Contract #: 04-0120F4Cty: SF/ALA Rte: 80 PM: 13.2/13.9File #: 69.25B

QUALITY ASSURANCE -- NON-CONFORMANCE REPORT

| Joint fit-up | Coating | Other | Component: Lift 13AW, Welds SEG3013Y-363, 369 |

Reference Description: Missed UT Indications Discovered by Quality Assurance on Lift 13AW SA
Diaphragms to Floorbeam Stiffeners

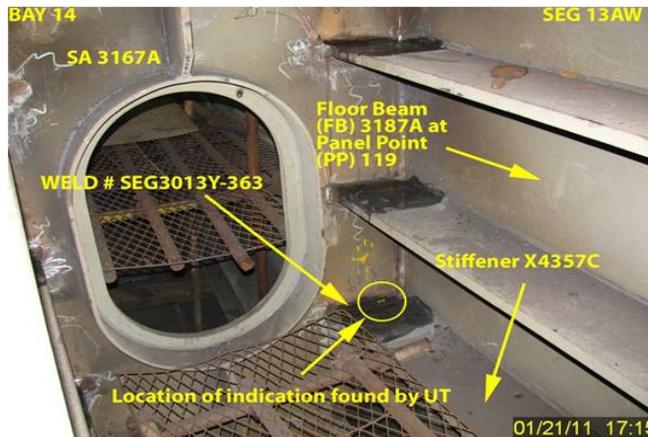
- One class "A" longitudinal indication measuring approximately 20mm in length.
- The depth of the indication is 27mm from face A.
- The db rating is +5.
- The material thickness is 35mm.
- The weld is identified as: SEG3013Y-363.
- The Weld is a Complete Joint Penetration (CJP), Tee-joint, joining the Stiffener X4357C of Floorbeam FB3187A to the Sub Assembly (SA) plate SA3167A at Panel point (PP) 119.
- The "Y" location of the indication is 155mm from the free edge of the stiffener (as shown in attached photograph).
- The indication is clearly marked on the component.
- The material is identified as Seismic Performance Critical Member (SPCM).
- The member is located in Bay 14.

- Two class "A" longitudinal indications measuring approximately 20mm and 22mm in length respectively.
- The depth of the indications is 30mm and 31mm respectively from face A.
- The db rating is +7 for each.
- The material thickness is 35mm.
- The weld is identified as: SEG3013Y-369.
- The Weld is a Complete Joint Penetration (CJP), Tee-joint, joining the stiffener X4357A of Floorbeam FB3191A to the Sub Assembly (SA) plate SA3167B at Panel point (PP) 119-1500.
- The "Y" location of the indications is 20mm and 120mm respectively from the free edge of the stiffener (as

The Notice of Witness Inspection Number (NWIT) is 08254. The indication is located inside the area that has been previously tested and accepted by ZPMC Quality Control (QC) personnel. As per the contract documents, ZPMC's QC personnel are required to perform 100% UT inspection of these welds. Attached photographs provide additional location details.

AWS D1.5-02 Table 6.3 "Specifies a class A indication for material thicknesses greater than 20mm through 38mm as having a db rating of +8 and lower."

ZPMC acknowledges that this indication was missed. Inspectors who miss indications are being tracked and retrained if they consistently miss indications. In this case the inspector was retained and retrained. ZPMC has also written an internal NCR for this incident to document and make sure responsible parties are aware. Based on this and attached acceptable NDT, ZPMC requests closure of this NCR.

This proposed resolution is acceptable. The documentation received is sufficient and the Department concurs that Non-Conformance ZPMC-0934 is closed.

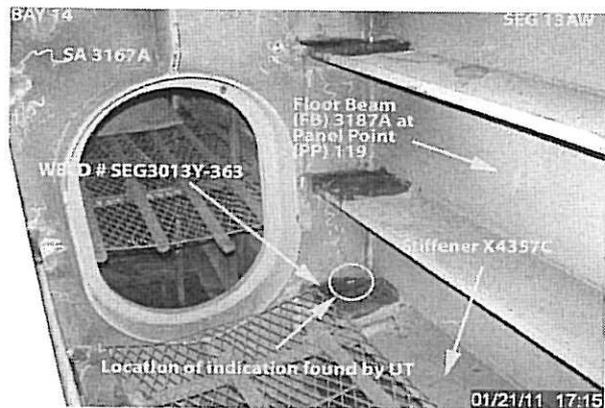
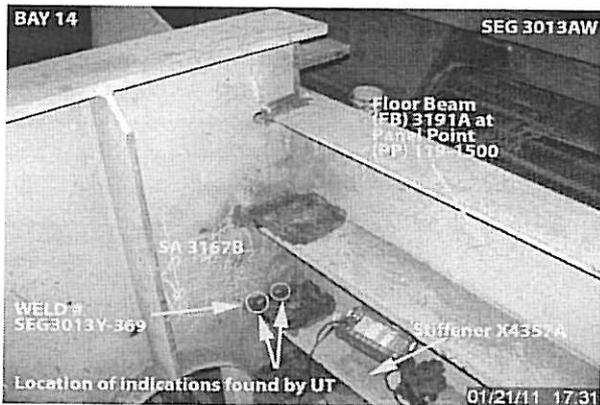
- One class "A" longitudinal indication measuring approximately 20mm in length.
- The depth of the indication is 27mm from face A.
- The db rating is +5.

- The material thickness is 35mm.
- The weld is identified as: SEG3013Y-363.
- The Weld is a Complete Joint Penetration (CJP), Tee-joint, joining the Stiffener X4357C of Floorbeam FB3187A to the Sub Assembly (SA) plate SA3167A at Panel point (PP) 119.

- The "Y" location of the indication is 155mm from the free edge of the stiffener (as shown in attached photograph).
- The indication is clearly marked on the component.

- The depth of the indications is 30mm and 31mm respectively from face A.
- The db rating is +7 for each.
- The material thickness is 35mm.
- The weld is identified as: SEG3013Y-369.

- The Weld is a Complete Joint Penetration (CJP), Tee-joint, joining the stiffener X4357A of Floorbeam FB3191A to the Sub Assembly (SA) plate SA3167B at Panel point (PP) 119-1500.

- The "Y" location of the indications is 20mm and 120mm respectively from the free edge of the stiffener (as

The Notice of Witness Inspection Number (NWIT) is 08254. The indication is located inside the area that has been previously tested and accepted by ZPMC Quality Control (QC) personnel. As per the contract documents, ZPMC's QC personnel are required to perform 100% UT inspection of these welds. Attached photographs provide additional location details.

AWS D1.5-02 Table 6.3 "Specifies a class A indication for material thicknesses greater than 20mm through 38mm as having a db rating of +8 and lower."

ZPMC acknowledged this problem and has issued an internal NCR. ZPMC has repaired the indications noted in the NCR and is providing NDT documentation after the repair to show the indication has been removed. Based on these actions, ZPMC requests closure of this NCR.
